**MANDATORY SERVICE BULLETIN**

**SUBJECT: DUKES INC. ELECTRIC FUEL BOOST PUMPS**

No. 2526  
ATA Code 28-20

**SUBJECT:** FUEL - DUKES INC. ELECTRIC FUEL BOOST PUMP INSPECTION AND OVERHAUL/REPLACEMENT.

**DUKES 4140 SERIES  
ELECTRIC FUEL BOOST PUMP**

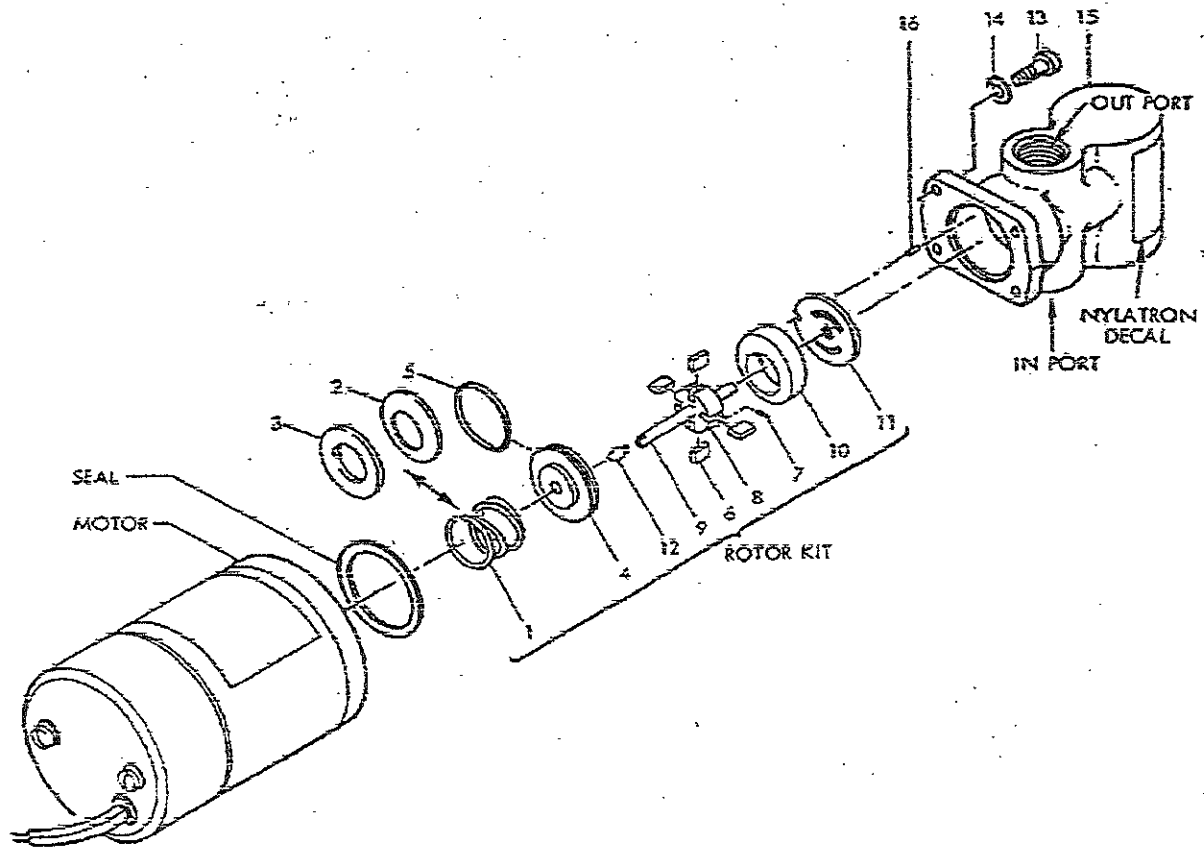
**PURPOSE:** THIS BULLETIN IS NECESSITATED BY THE FACT THAT SOME OF THE CARBON VANES IN THE OLDER PUMPS HAVE SHATTERED DUE TO THE INGESTION OF CONTAMINATES INTO THE PUMP. IN SOME CASES THESE PARTICLES HAVE FOUND THEIR WAY TO THE MAIN ENGINE FUEL PUMP AND CAUSED THE REED TYPE VALVES TO MALFUNCTION, RESULTING IN REDUCTION OR LOSS OF ENGINE POWER. COMPLIANCE IS ACCOMPLISHED BY THE INSTALLATION OF DUKES ROTOR KIT 2140-220. THIS KIT WILL REPLACE CARBON VANES WITH VANES MADE OF NYLATRON, WHICH IS EXTREMELY RESISTANT TO SHATTERING (SEE ITEM NO. 6.)

**NOTE:** ANY PUMP EITHER NEW OR OVERHAULED BY DUKES INC. AFTER 1/1/88 ALREADY CONTAINS NYLATRON VANES. THESE PUMPS CAN BE IDENTIFIED BY EITHER A YELLOW DECAL ON THE BASE OF THE PUMP OR BY THE LETTERS "NV" FOLLOWING THE PART NUMBER. PUMPS IDENTIFIED AS CONTAINING NYLATRON WILL NOT REQUIRE SERVICE UNTIL THE TEN YEAR TBO HAS BEEN REACHED.

**COMPLIANCE:** COMPLIANCE MUST BE ACCOMPLISHED BY EITHER REPLACEMENT WITH A NEW PUMP, OR OVERHAUL OF THE EXISTING PUMP BY DUKES INC. OR AN FAA CERTIFIED REPAIR STATION (REQUIRED COMPONENT PARTS MUST BE PURCHASED FROM BEECHCRAFT OR THEIR AUTHORIZED DEALERS.) COMPLIANCE IS MANDATORY WITHIN THE NEXT 100 HOURS OR NOT LATER THAN 6/1/94.
